**Board of Adjustment
Special Meeting Agenda
Fraser Town Hall, 153 Fraser Avenue
Wednesday February 26, 2025
5:30 PM - 6:30 PM**

a. Appeal Of Administrative Variance Denial - The Ascent

Project Name: The Ascent – Final Plat, Site Plan, and Administrative Variance

RE: The Ascent – Final Plat, Major Site Plan, Administrative Variance
Planning Review Comments (1st Referral Review)

LIGHTING PLAN

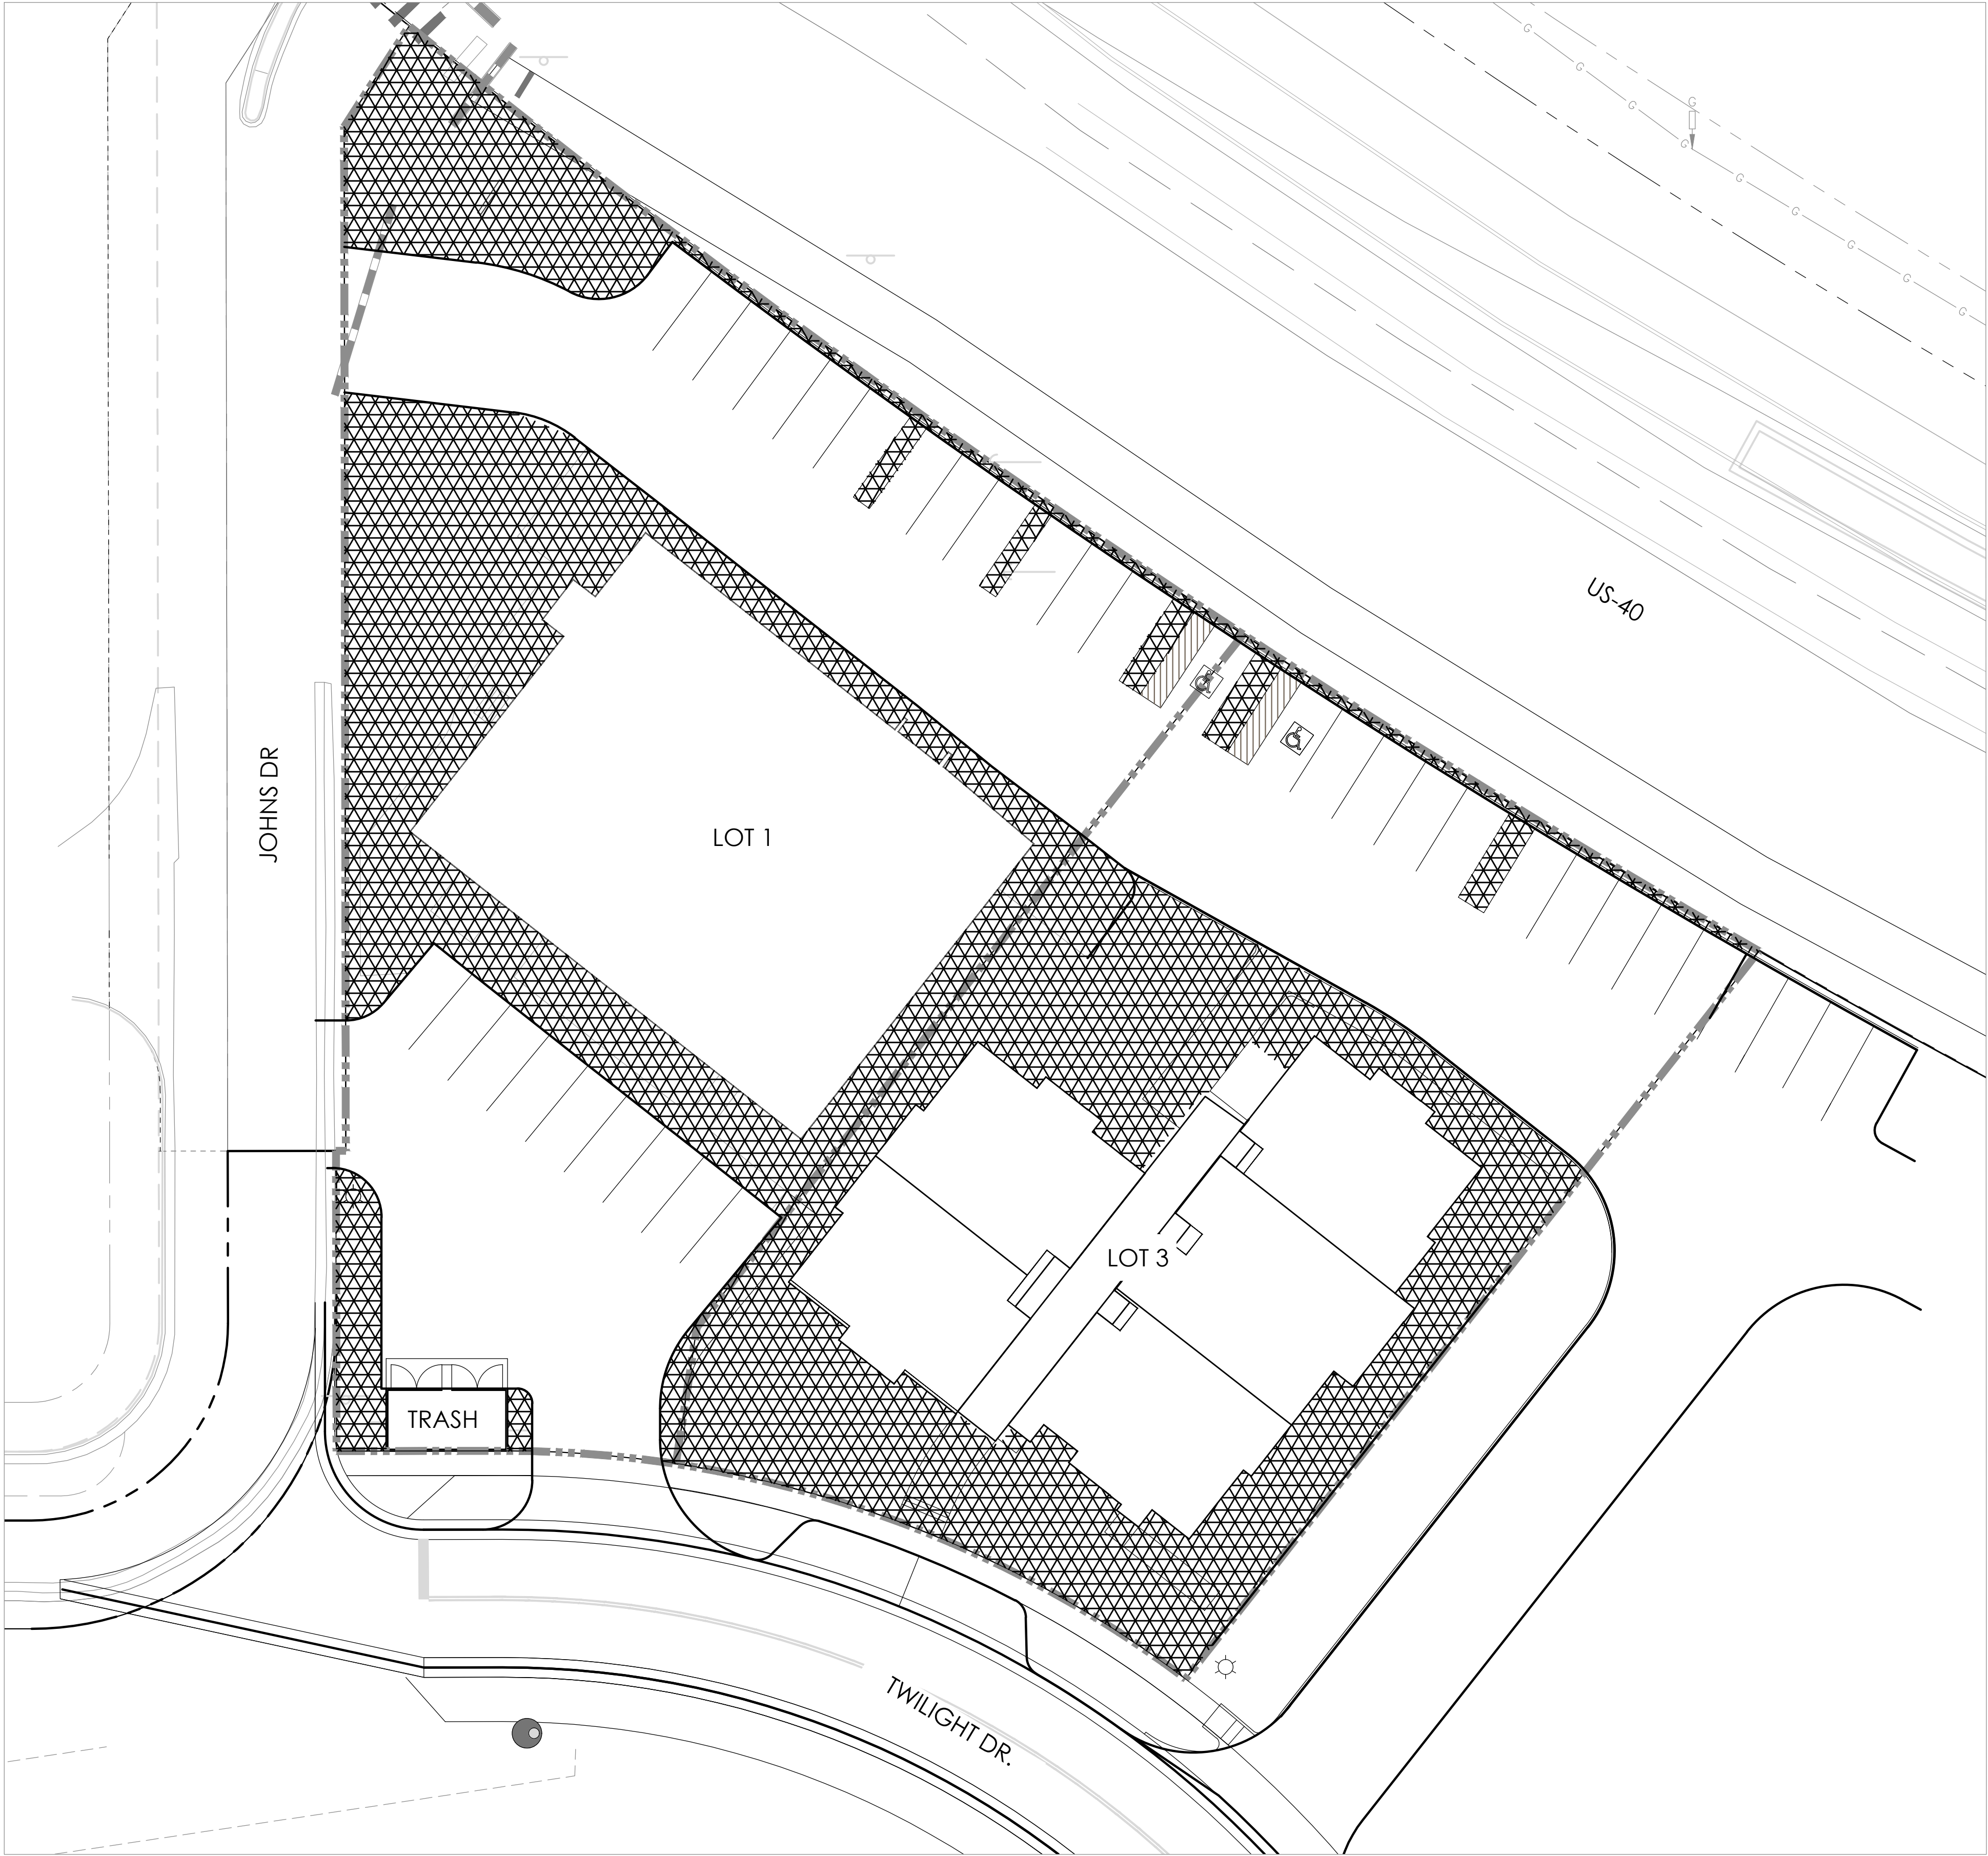
Sheet 12 – Lighting Plan

- 39) [Sec. 14-5-30](#) and [Sec. 19-4-195](#) include site lighting requirements and guidance for sites in the Business District zone. Lighting is to be appropriate for public safety and security, while minimizing undesirable effects of excessive illumination such as glare, sky glow and light pollution.
- a. The lighting plan provided only depicts existing pedestrian and parking lot lighting on the east side of the site. Please update the plan to include detail sufficiently addressing items 1 through 8 in Sec. 14-5-30.
 - b. You may incorporate the photometric plan as required in item (8) into this sheet.
 - c. Additional parking lot lighting is suggested for the southwest and southeast parking areas to provide minimal levels for pedestrian safety.
 - d. Please be sure to include any exterior lighting that is to be provided on the building exteriors into this sheet.
